MEMORANDUM DATE: October 7, 2020

RE: **31 South Golfview Unit #13**

TITLE: **HRPB Project Number 20-00100189:** Consideration of a Certificate of Appropriateness (COA) for accordion shutter installation for the condominium unit located at 31 South Golfview Road #13; 38-43-44-27-36-001-0130. The subject property is a contributing resource to the South Palm Park Local Historic District and is located in the Medium Density Multi-Family Residential (MF-30) Zoning District.

31 South Golfview Road
Original Roller Awning Shutters

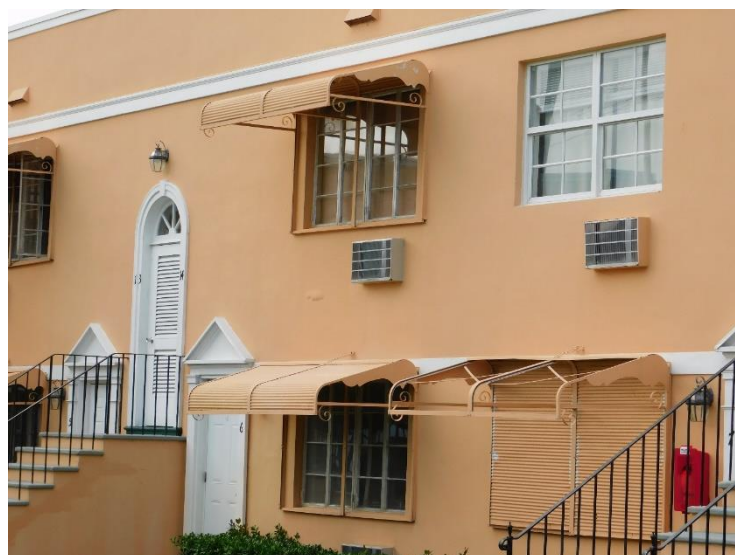
The proposed project is not consistent with Goal 1.4 of the Comprehensive Plan, which encourages preservation and rehabilitation of historic resources, since accordion shutters are very intrusive and cannot be stored out of sight when not in use. The proposed project is also not in compliance with Policy 3.4.2.1 requires that properties of special value for historic, architectural, cultural, or aesthetic reasons be restored and preserved through the enforcement of the City’s Historic Preservation Ordinance to the extent feasible. Per the City’s Historic Preservation Ordinance (LDR Sec. 23.5-4), the Lake Worth Beach Historic Preservation Design Guidelines, and the Secretary of Interior Standards for Rehabilitation, exterior alterations should be substantiated by documentary, physical, or pictorial evidence. The proposed accordion shutters are not appropriate and do not replicate the original roller awning shuttering system utilized in the structure.
